Work Order ID 163002

DART AEROSPACE LTD		Work Order:	63002
Description: Bar		Part Number:	D3196-4
Inspection Dwg: D3196	Rev: C	Page 1 of 1

DESIGN	DRAWN BY	DART AEROSPACE LTD
90	13	HAWKESBURY, ONTARIO, CANADA
CHECKED	APPROVED	DRAWING NO.
AM	13	D3196
DATE	TITLE	SHEET 1 OF 3
06.10.31	BAR	SCALE 1:4
REV.	DESCRIPTION	DATE
A	NEW ISSUE	03.06.25
B	ADD D3196-5	06.09.25
C	ADD SLOTS ON -1; REMOVED -5	06.10.31

DRAWING NO. D3196	TITLE BAR	REV. C	DART AEROSPACE LTD ENGINEERING ORDER	D.E.O. NO. D3196-C-1	SHEET NO. SHEET 1 OF 2	SCALE NTS
DRAWN <i>ASS</i>	CHECKED <i>[Signature]</i>	MFG. APPR. <i>[Signature]</i>	APPROVED <i>[Signature]</i>	DE APPR. <i>[Signature]</i>		
DATE 08.08.27	DATE 08.08.28	DATE 08.08.29	DATE 08.08.29	DATE 08.08.29	DATE 08.09.04

D3196-1 BAR

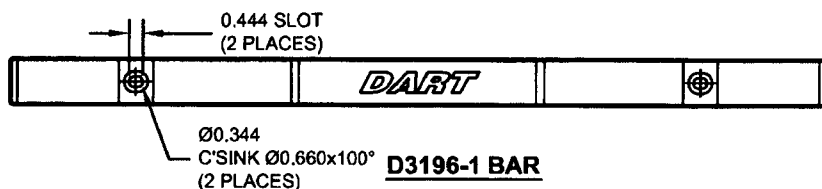
SHEET 1 MODIFY SLOT DIMENSIONING ON D3196-1 AS SHOWN:

NOTE: THIS CHANGE HAS BEEN DONE TO CLARIFY SLOT DIMENSIONS ONLY. NO CHANGES HAVE BEEN MADE TO THE PARTS
SEE NCR 08-051 FOR FURTHER INFORMATION
ALL OTHER INFORMATION REMAINS UNCHANGED

D3196-3 BAR

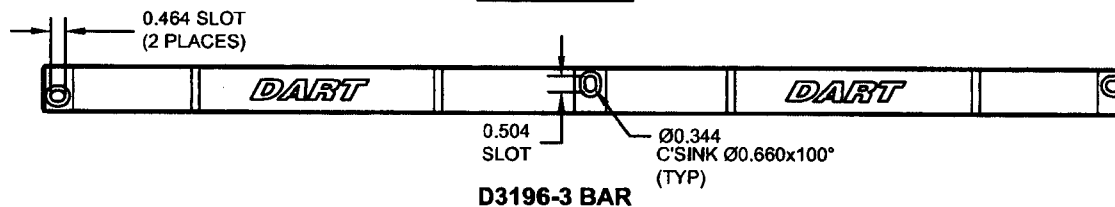
SHEET 2 MODIFY SLOT DIMENSIONING ON D3196-3 AS SHOWN:

D3196-4 BAR

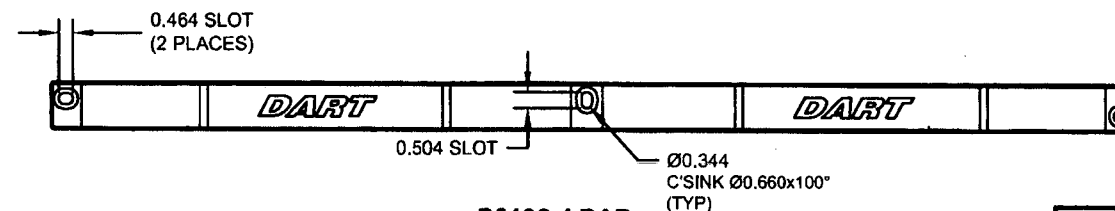
SHEET 3 MODIFY SLOT DIMENSIONING ON D3196-4 AS SHOWN:
